STAFF REPORT: MARCH 13, 2024, REGULAR MEETING
APPLICATION NUMBER: HDC2024-00065
ADDRESS: 9230 DWIGHT
HISTORIC DISTRICT: BERRY SUBDIVISION
APPLICANT: BORA GULARI
OWNER: BORA GULARI
DATE OF PROVISIONALLY COMPLETE APPLICATION: FEBRUARY 8, 2024
DATE OF STAFF SITE VISIT: FEBRUARY 21, 2024

SCOPE: ALTER GARAGE/BOATHOUSE

East elevation showing proposed work; drawing from application documents.

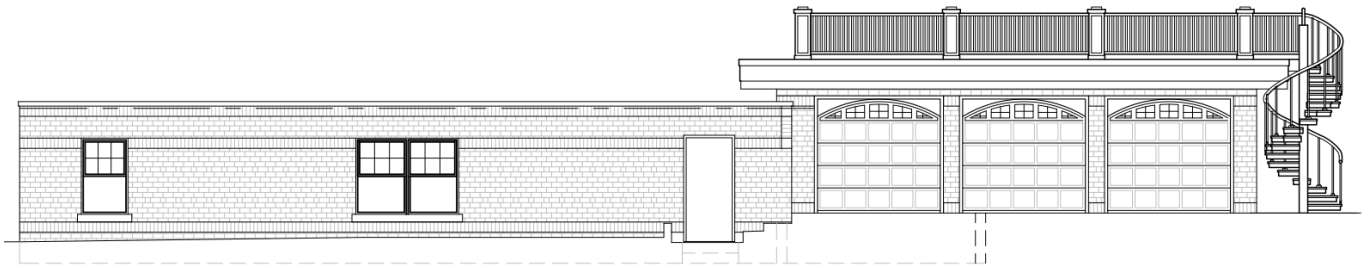
The applicant proposes to alter the garage/boathouse by eliminating the hip roof and constructing a flat roof. The flat roof would be topped by a deck, accessed by a spiral staircase. The submitted elevation also depicts three new garage doors.

- The proposed flat roof and deck is contrary to the Secretary of the Interior’s Standards direction on exterior alterations for several reasons.
 - Standard #9 requires that “new additions, exterior alterations, or related new construction shall not destroy historic materials that characterize the property.” The proposed work destroys the character-defining hip roof and clay tile.

- Standard #9 requires that “new work ... shall be compatible with the massing, size, scale, and architectural features” of the building and the district. The proposed work would alter the hip roof massing of the building and introduce a flat roof which is out of character for the district.

- Standard #10 requires that additions and new construction be reversible. The proposed work would eliminate a tile roof that is likely irreplaceable.

- The proposed work eliminates a highly distinctive clay tile roof without showing that it is beyond repair. Even if it were beyond repair, the Standards would direct that it be replaced with a roof of similar design, color, and texture.
- The proposed work eliminates the hip roof massing that is a defining feature expressing the building's Italian Renaissance style and that creates an important visual relationship with the main house.
- The proposed work introduces a flat roof that conflicts with the Elements of Design and is visually incompatible with the building and the district.
- Not enough information is provided to confirm that the proposed work uses materials, colors, and textures that are compatible with the building and the district.

Therefore, staff recommends that the Commission issue a Denial for the proposed work as it fails to meet the Secretary of the Interior's Standards for Rehabilitation, in particular:
